TOLERANCE	Decimal	DATE 2008. 12. 29.		 RF & MICROWAVE TECHNOLOGY Tel : 82-32-347-8015 Fax : 82-32-347-8017
	Angle	APPROVED BY	S.J.YOUN	
MATERIAL	_____	CHECKED BY	E.H.KIM	KJ COMTECH CO.,LTD. TITLE BNC75-BJ-3C-179
		DRAWN BY	I.C.KIM	
FINISH	_____	SCALE	UNIT	A4 DWG NO. CN00335-7/2 REVISION A SHEET 1 of 1
		2.5/1	mm

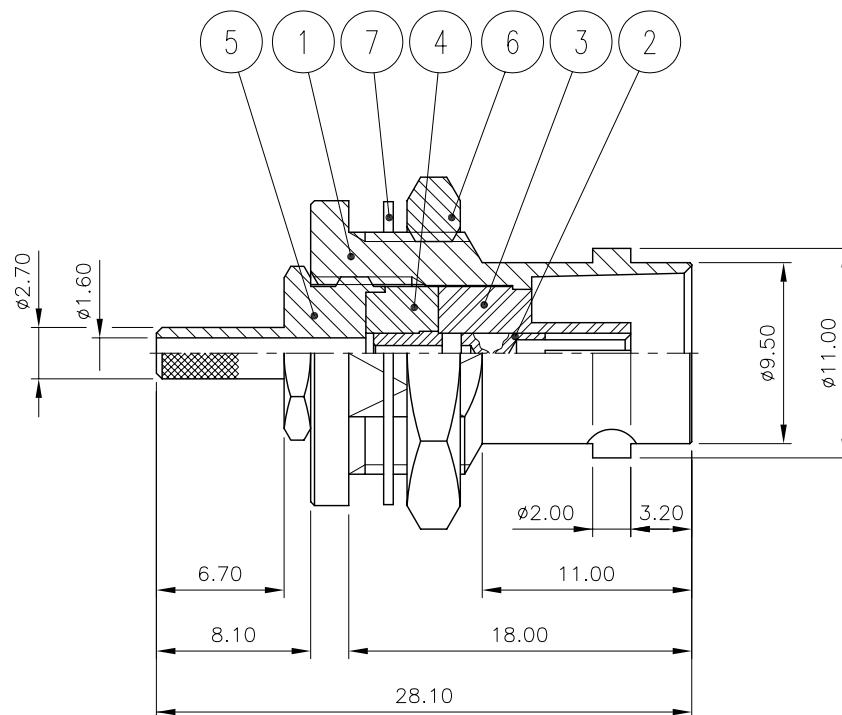
REVISION		
REV	DESCRIPTION	DATE
IR	최초 개정	2001.06.25.
A	[설번처리 No.200812-0016] 부품 치수 부적합으로 인한 조립 불가 INSULATOR 전장 길이 변경	2008.12.29.

7	WASHER	1	MBsBD	Nickel Plate	DWA00022-5/1 (Q6008)
6	NUT	1	MBsBD	Nickel Plate	DNT00020-5/1 (N6002)
5	BACK NUT	1	MBsBD	Nickel Plate	DBN00069-5/1 (P6426)
4	INSULATOR	1	TEFLON		DIN00431-N/1 (H6010)
3	INSULATOR	1	TEFLON		DIN01470-N/1 DIN00587-N/1 (H6509)
2	CONTACT	1	BeCu	Gold Plate	DCT00498-5/1 (E6479)
1	BODY	1	MBsBD	Nickel Plate	DBD00626-5/1 (D6491)
NO.	DESCRIPTION	Q'TY	MATERIAL	PLATING	CODE
